RE: Amendment to the Dane County Water Quality Plan, Revising the Central Urban Service Area Boundary and Environmental Corridors in the Nine Springs Neighborhood Area in the Cities of Fitchburg and Madison.

**Staff Analysis of Proposed Amendment to the Dane County
Land Use and Transportation Plan, Farmland Preservation Plan and
Water Quality Plan Revising the Central Urban Service Area Boundary
and Environmental Corridors in the Nine Springs Neighborhood Area
in the Cities of Fitchburg and Madison**

Subject: Central Urban Service Area Amendment - Nine Springs Neighborhood

Map 1

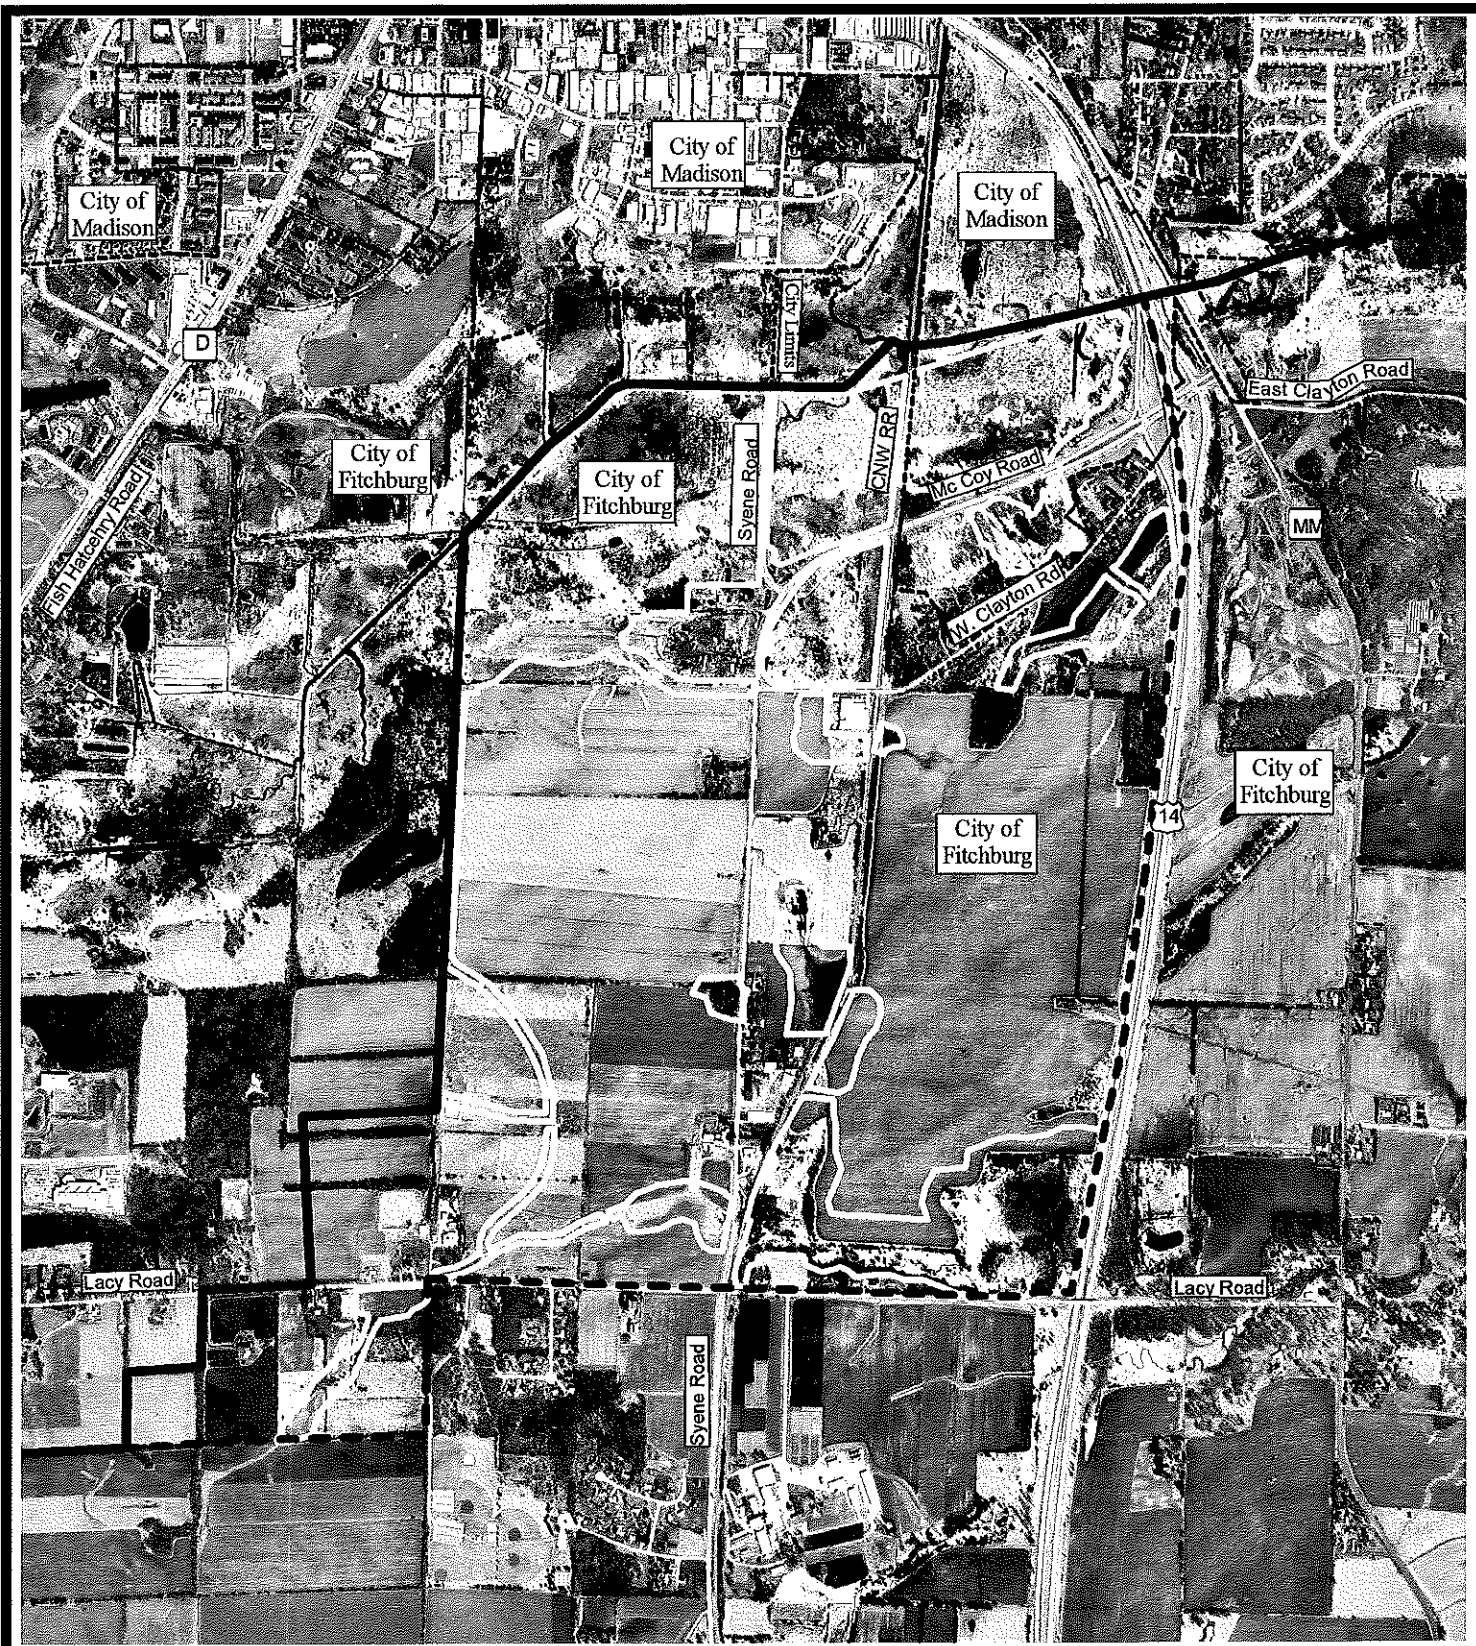
Archeological information on file at the RPC indicates the presence of prehistoric cultural sites within the proposed amendment area in Section 2 (hatched area on Map 1). The DNR Bureau of Endangered Resources has delineated the boundary of a large community of rare or threatened species in and near the amendment area. Map 3 shows the area in relationship to the existing CUSA boundary and the proposed amendment. Most of the natural community in the amendment area is proposed for inclusion in environmental corridors. A portion of the natural community, however, has not been included in environmental corridors in the proposed amendment. This portion is shown on Map 4. The City of Fitchburg's E-Way Committee recommended that this portion (part of the McKeown parcel) be included in the E-Way conservancy area. The Nine Springs Neighborhood Plan states that "if these lands are to be publicly acquired, the acquisition would be the responsibility of Dane County and/or WNDR through purchase or land exchange." Because this land may be supporting rare and endangered resources and because there are archeological sites located in this area, it is recommended that the area (shown on Map 4) be included in environmental corridors and protected from disturbance until it can be determined whether it is part of the rare and threatened species community located in this area, and whether archeological sites are present.

Map 2

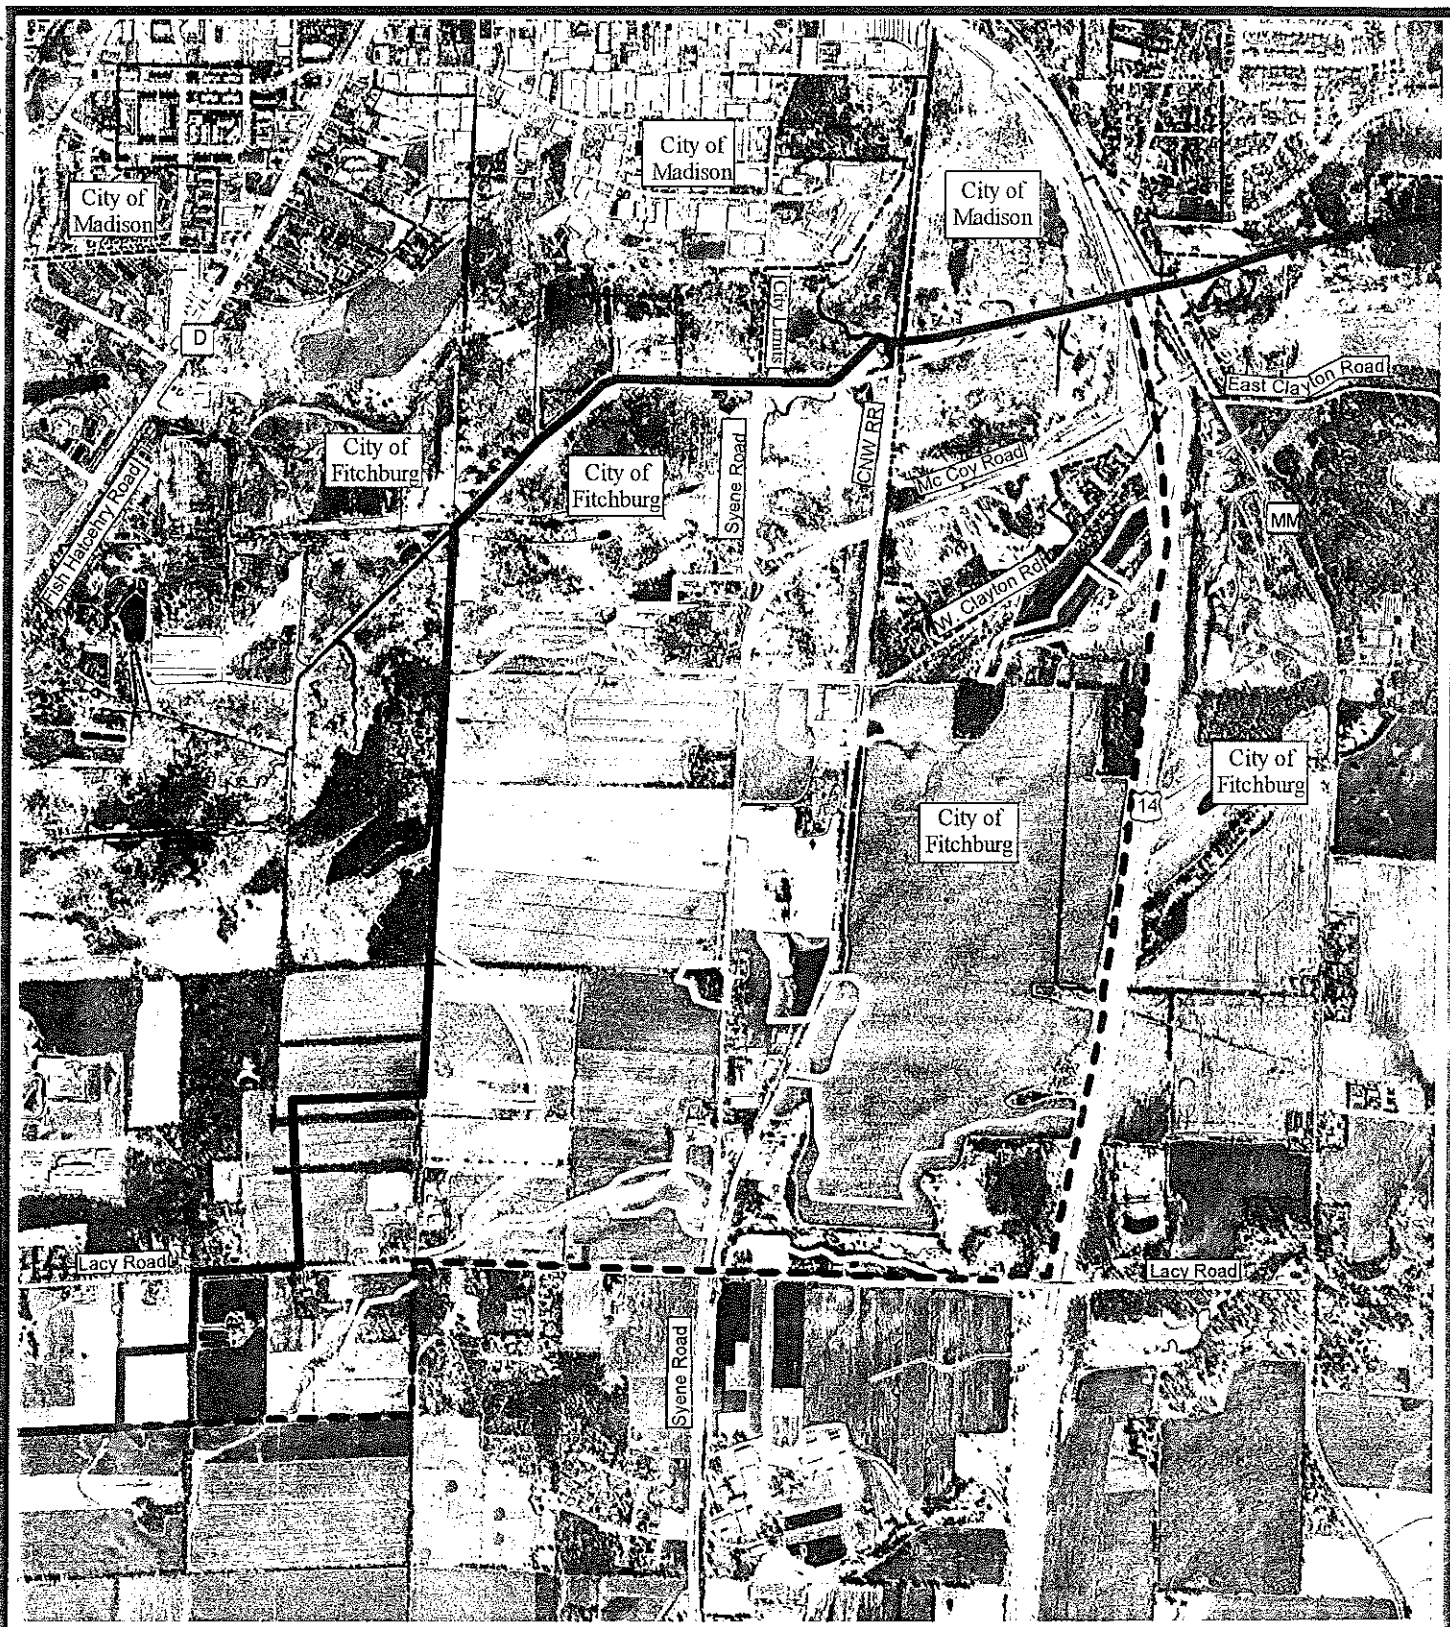
Land Use. The proposed amendment area is currently in agricultural or open space use (see Map 2). Present land uses adjacent to the proposed amendment are:
